**Acoustics — Noise emitted by
machinery and equipment —
Guidelines for the use of basic
standards for the determination of
emission sound pressure levels at a
work station and at other specified
positions**

Reference number
ISO 11200:2014/Amd.1:2018(E)

AMENDMENT 1

Page 11, Clause 5

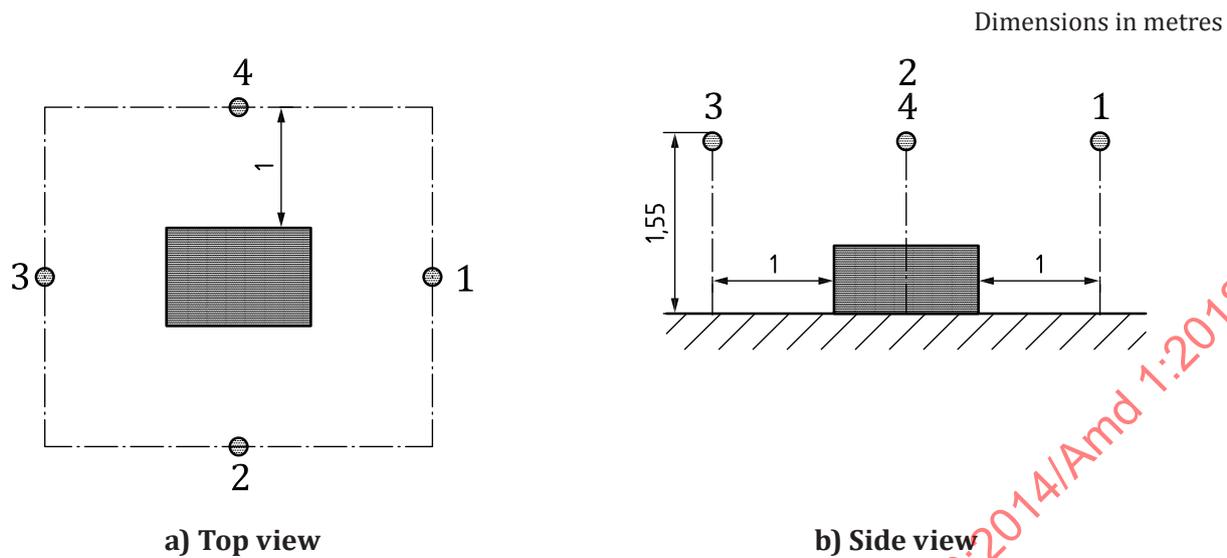
Delete the following first two lines of the text:

“Overview of the methods offered in the ISO 11201, ISO 11202, ISO 11203, ISO 11204 and ISO 11205 group for determining the emission sound pressure level at work stations and other specified positions”
